UNITED STATES PATENT AND TRADEMARK OFFICE

APPLICATION NO.	FILING DATE	FIRST NAMED INVENTOR	ATTORNEY DOCKET NO.	CONFIRMATION NO.
10/075,031	02/12/2002	Sidney F. Hauschild	AMS-057	7514

Office Action Summary

DETAILED ACTION

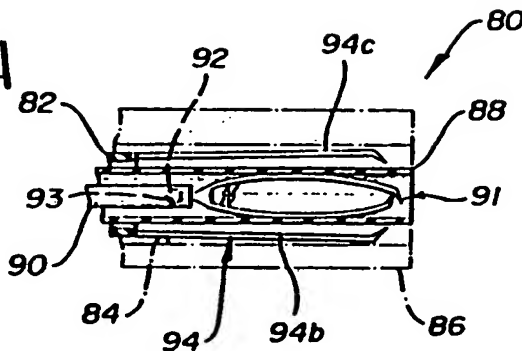
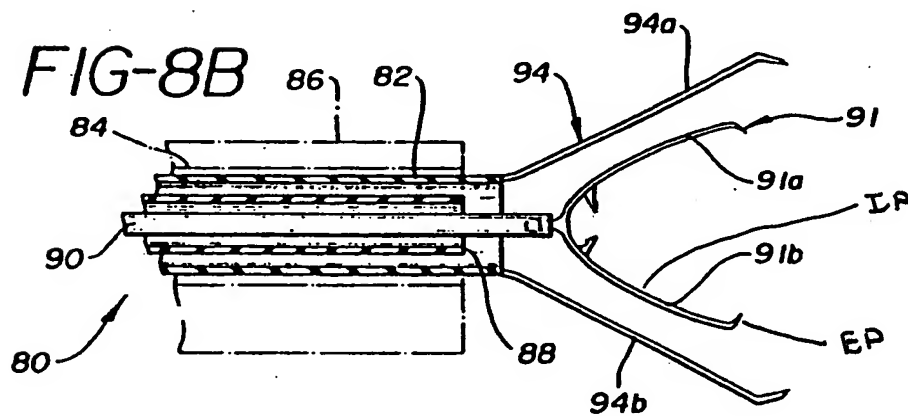
Claims 1, 3, 8, 9 and 13 are rejected under 35 U.S.C. 103(a) as being unpatentable over Nakao et al. (U.S. 5,156,609) in view of Gauderer et al. (U.S. 6,361,540) with reference to Exhibit A. Nakao et al. teaches an apparatus capable of retrieving a foreign body comprising: an axially elongate member 88 having a foreign body capturing assembly 91, the elongate member 88 having an inner lumen that is sized and shaped to receive a viewing apparatus; a substantially tubular member 82 having a distal end and an inner lumen that is sized and shaped to receive the elongate member 88; the elongate member 88 and tubular member 82 being operatively associated to move between an open position with the foreign body capturing assembly 91 adapted to receive a foreign body, and a closed position with the foreign body

capturing assembly 91 adapted to control said foreign body, and a cylindrical sheath 86 having an outer diameter, a length and an inner lumen 84 that is sized and shaped to afford sliding passage of the tubular member 82 and the elongate member 88 while in the closed position; wherein the foreign body capturing assembly 91 comprises a plurality of tines 91a & 91b, each tine 91a/b having an inclined portion IP and a foreign body engagement portion EP, each tine 91a/b being constructed to be resiliently biased toward the open position, and the tubular member 82 being arranged so that movement toward the closed position causes the distal end of the tubular member 82 to engage the inclined portions IP of the tines 91a/b to cam the tines 91a/b toward the closed position; wherein the sheath 86 is substantially cylindrical with an outer diameter and the lumen 84 of the sheath 86 is constructed to afford rotation of the elongate member 88 and tubular member 82 about the elongate axis of the elongate member 88; wherein the tines 91a/b are each constructed to be resiliently biased toward the open position, and the tubular member 82 being arranged so that movement toward the closed position causes the distal end of the tubular member 82 to engage the inclined portion IP of the tines 91a/b to cam the tines 91a/b toward the closed position, and in the open position, at least a portion of the tines 91a/b and the foreign body engagement portions EP project radially beyond the outer diameter of the sheath 86.
